RHODE ISLAND DEPARTMENT OF TRANSPORTATION

**2019 Paver Placed Elastomeric Surface Treatment C1**

NOTICE TO PROSPECTIVE BIDDERS

ADDENDUM NO. 2 Prospective bidders and all concerned are hereby notified of the following changes in the Plans, Specifications, Proposal and Distribution of Quantities for this contract. These changes shall be incorporated in the Plans, Specifications, Proposal and Distribution of Quantities, and shall become an integral part of the Contract Documents.

SIDEWALK DETAILS  
PIPPIN ORCHARD RD

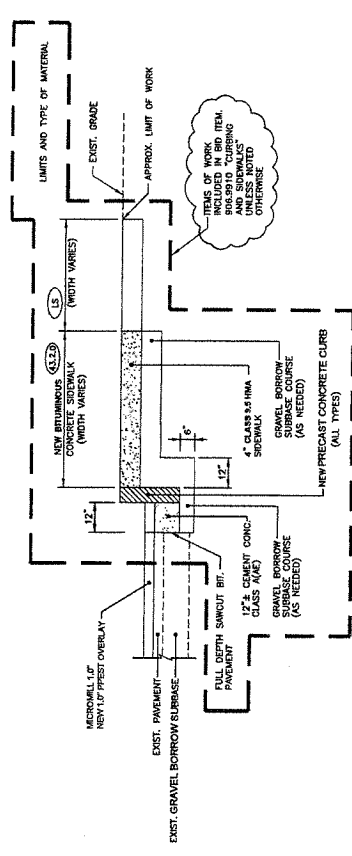
Remove plan sheet no. 11 and replace with revised plan sheet no. 11 attached to this Addendum 2. Sidewalk Details Pippin Orchard Rd Note 4 has been changed.

- CUT NEXT LINE UP FROM CURB LINE AND REMOVE AND REGRADE AS NECESSARY. ASPHALT PAVEMENT AND GRAVEL BASE, REMOVE CURB AND INSTALL NEW CURB. REPLACE WITH CLASS 3 CONCRETE TRANSITION CURB STD. DTL. 7.2.2. RADIUS CURB SHALL BE REPLACED WITH PRE-CAST CONCRETE TRANSITION CURB STD. DTL. 7.2.2.

- THE CONTRACTOR SHALL PROVIDE A SAWCUT, 6" FROM FACE OF EXISTING CURB. TRIMMING SHALL BE NECESSARY TO SEPARATE THE EXISTING BITUMINOUS CONCRETE FROM THE EXISTING RETAINING WALL, AS DIRECTED BY THE ENGINEER.

- THE COST OF TRIMMING AND THE GRADING FOR CURB INSTALLATION WILL BE INCLUDED IN THE COST OF THE CURB. THE TRIMMING AND THE GRADING LIMITS SHALL BE A MINIMUM 1'-0" IN FRONT OF AND 1'-0" IN BACK OF THE NEW CURB OR TO EXISTING MAIL BOXES, TRAFFIC SIGNALS, ETC. FOR PROPER CURB INSTALLATION.

- ALL MAIL BOXES AND TRAFFIC SIGNALS LOCATED WITHIN THE SIDEWALK PAY LIMITS THAT REQUIRE REMOVAL AND RESET OR REPLACEMENT WILL BE PAID FOR SEPARATELY UNDER THE APPROPRIATE UNIT BID PRICE.

- REMOVAL AND REPLACEMENT OF APRON STONE SHALL BE INCLUDED IN BID ITEM 906.9910 "CURBING AND SIDEWALKS"
